### **FIAT SP 11-19**

Public hearing on the request of Suburban Collection for Fiat for Preliminary Site Plan, Stormwater Management Plan and Special Land Use Permit approval. The subject property is located on the west side of Haggerty Road, south of Grand River Avenue, in Section 24 of the City. The property totals 8.15 acres. The zoning of the parcel is B-3, General Business.

## PLANNING REVIEW

**SUBJECT: Fiat of Novi, Revised Preliminary Site Plan and Special Land Use,  
SP#11-19A, Traffic Review**

**Existing Chrysler/Dodge/Jeep/Ram Site Proposed to Accommodate New Fiat Dealership**

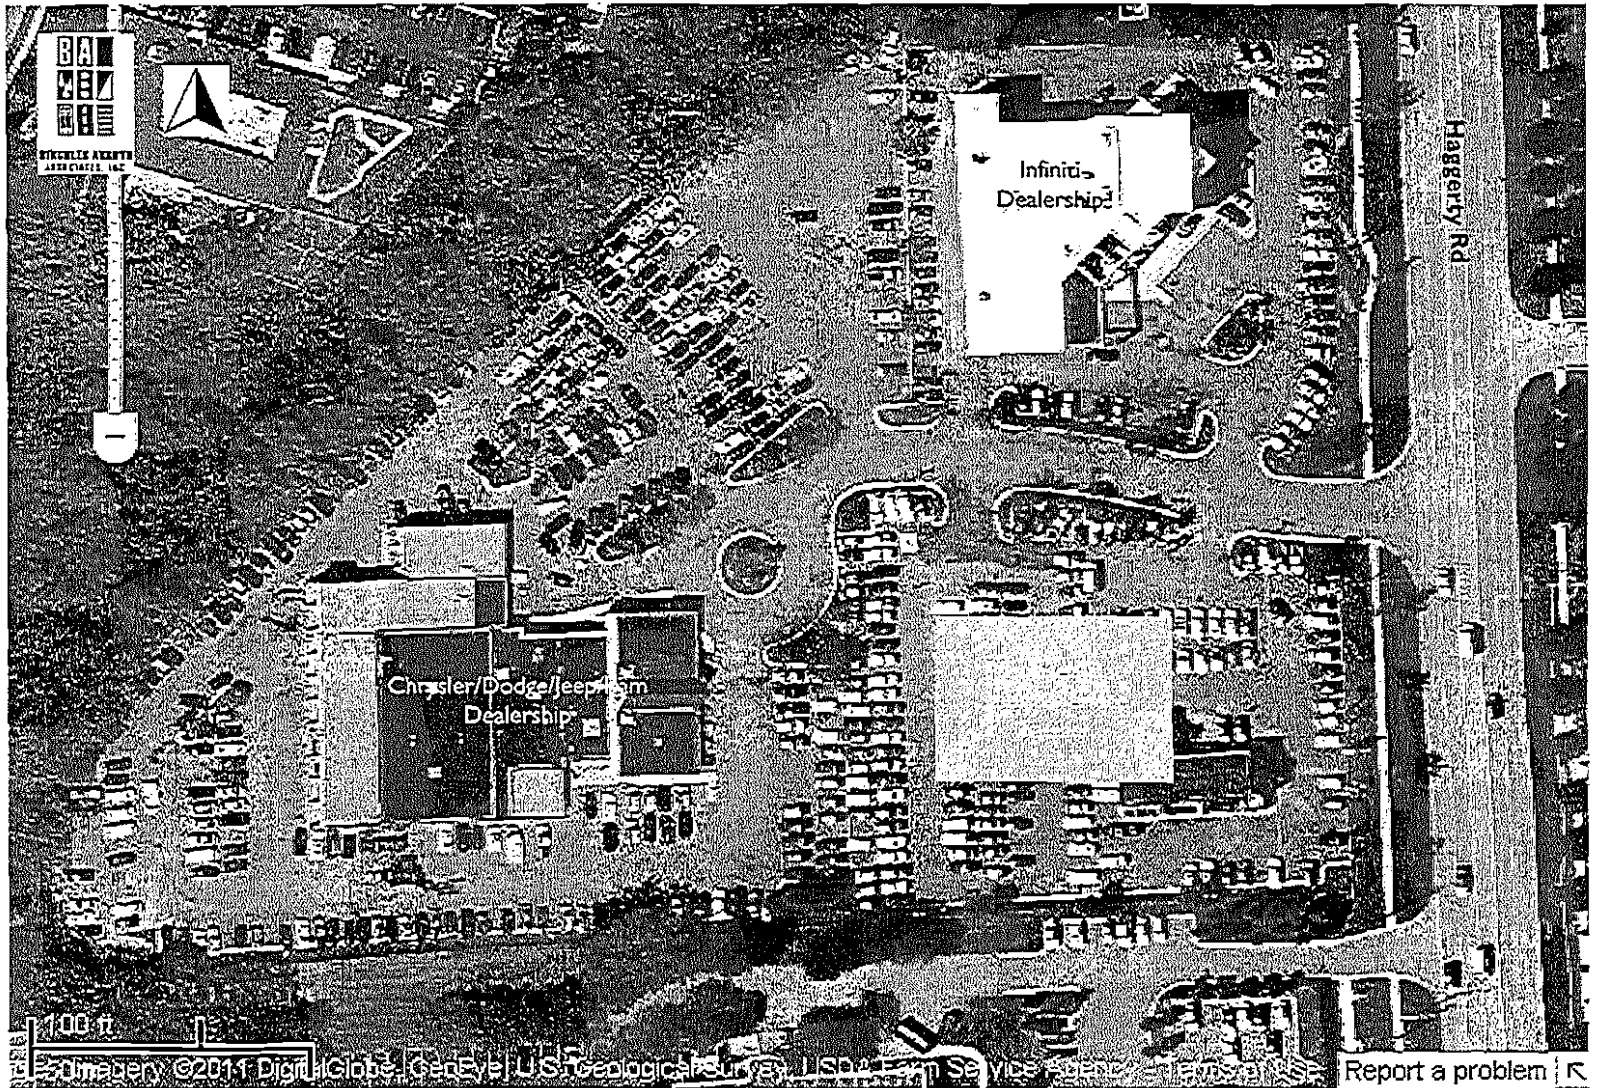
5. As can be seen on the attached aerial photo, Haggerty at this location is already served by a two-way left-turn lane.
6. Neither the City of Novi nor the Road Commission has warrants for a right-turn lane and/or taper at a site access drive on a multi-lane road, and we have not evaluated the MDOT warrant for such. No vehicular access improvements have been proposed.
